CITY PLANNING COMMISSION

APPLICATION: Special Permit to construct a 2,118+ square foot Long John Silvers Restaurant with a drive-up service window.

LOCATION: Southeast corner of Northgate Boulevard and Winterhaven Avenue

**EXHIBIT A**  
**SITE PLAN**

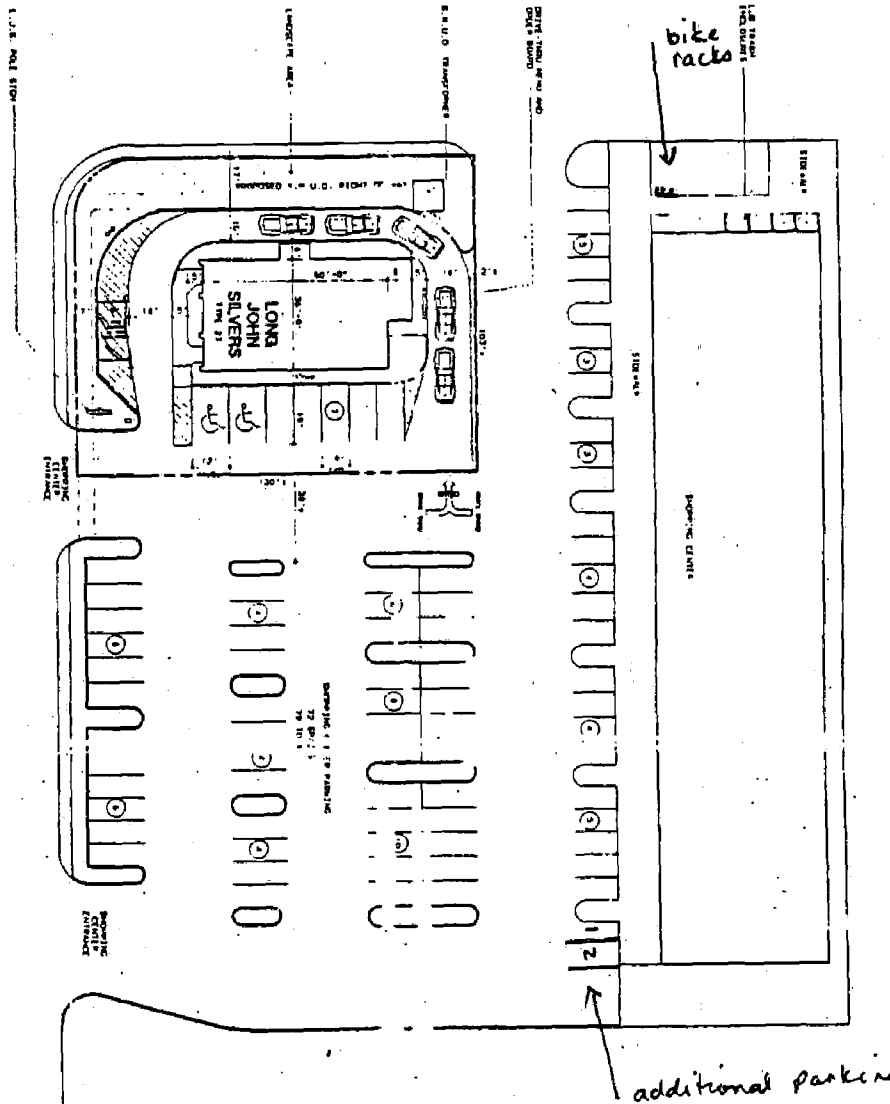
The shopping center presently has 73 parking spaces. The site plan for Long John Silver's depicts seven parking stalls and one parallel stall. The City does not permit parallel parking stalls, therefore, the total proposed parking for the site is 80 parking stalls. The combined parking required for the shopping center and Long John Silvers is 82 parking spaces.

The two additional parking spaces can be provided at the southeastern corner of the parking area if the existing bike racks are relocated to the northeastern corner of the site, as shown on Exhibit A. The other alternative is that the applicant reduce the capacity of the restaurant by six seats. Staff is not supportive of a variance from the required parking as there is no circumstances unique to this proposal that would justify the granting of a variance and thus, granting of a variance in this situation would be a grant of special privilege.

1. The applicant shall submit a landscape plan for staff review and approval prior to issuance of building permits. Provide interior landscaping and screen the SMUD transformer.
2. The applicant shall record the lot line merger for the site prior to issuance of building permits.
3. All trash enclosures shall be designed to City standards.
4. The applicant shall provide additional parking spaces and relocate the bike racks, as shown on Exhibit A or reduce seating for the restaurant by six seats, for a total capacity of 78 seats.
5. A signage program shall be submitted for review and approval of staff prior to issuance of sign permits. Detached signage shall be monument type and shall not exceed 12 feet in height measured from the top of the sidewalk.
